SUBJECT: Addendum No. 4

REFERENCE: Invitation To Bid (ITB) for HOU Restroom Renovation Phase 2; Solicitation No. HHG-HRESTR-2022-019; Project No. PN209A

NARRATIVE ADDENDUM NO. 4

SHEET NAME:
ELECTRICAL POWER PLAN - GATE 20-23
RESTROOMS
SHEET No. EP101 SCALE: 1/4" = 1'-0"

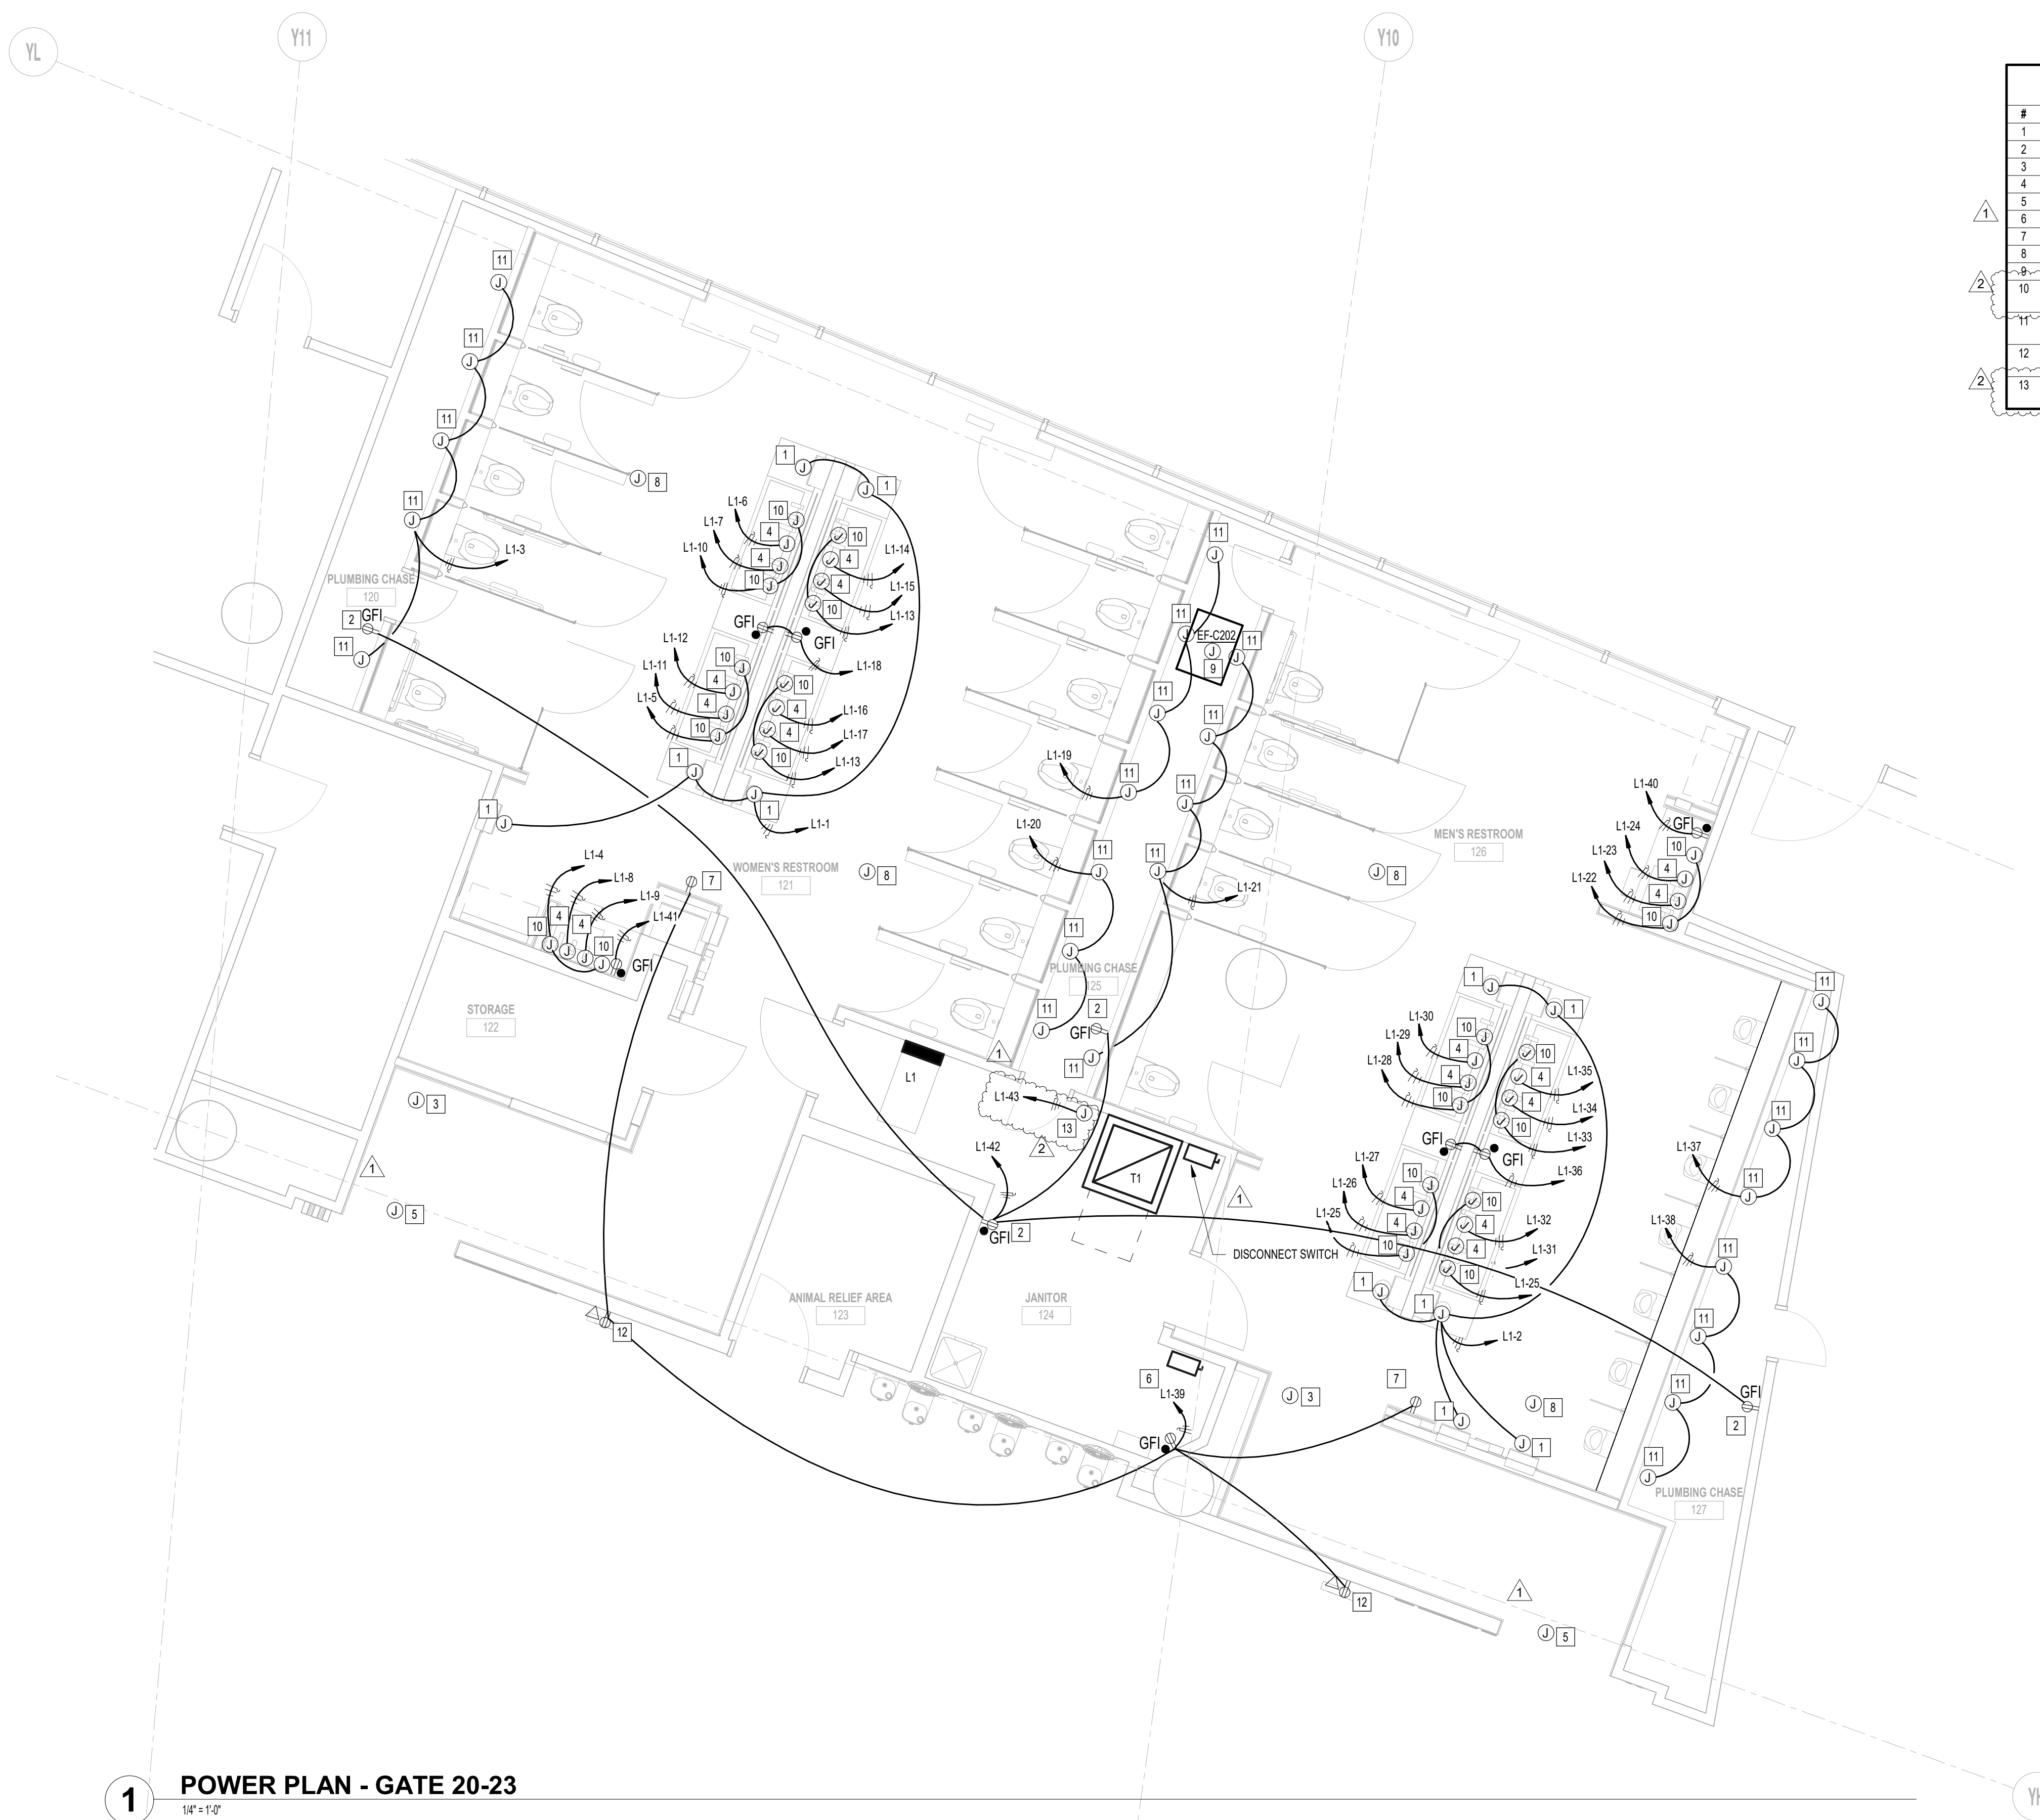
EG401	Electrical schedules revised, refer sheet attached.
	EL101, EL102, EL103	J-box for power to LED Mirrors added.
	EP101, EP102, EP103	<ul style="list-style-type: none"> a. J-box for stall lights on sheets. b. J-box for soap/water faucet sensor at all lavatory island.
	EP104	Floor plan background revised. Refer sheet attached.
	MG001	Applicable codes legend revised.
	PG301	Soap Dispenser diagram added.
	PG401	Plumbing fixture schedule updated to show Splash Lab plumbing fixture schedule.
	PP101, PP102, PP103	Note to provide 3 gallon soap dispenser reservoirs added.
	T-101, T-102, T-103	Updated the smart restroom technology and keynotes on the Floorplans.
	T-401, T-402, T-403	Updated Line Diagrams to accommodate the updated smart restroom technology.
	T-500	Updated Flat Panel Display Mount Detail to include the new MINI PC.
	T-600	Updated Equipment Schedule to include the technology additions and subtractions
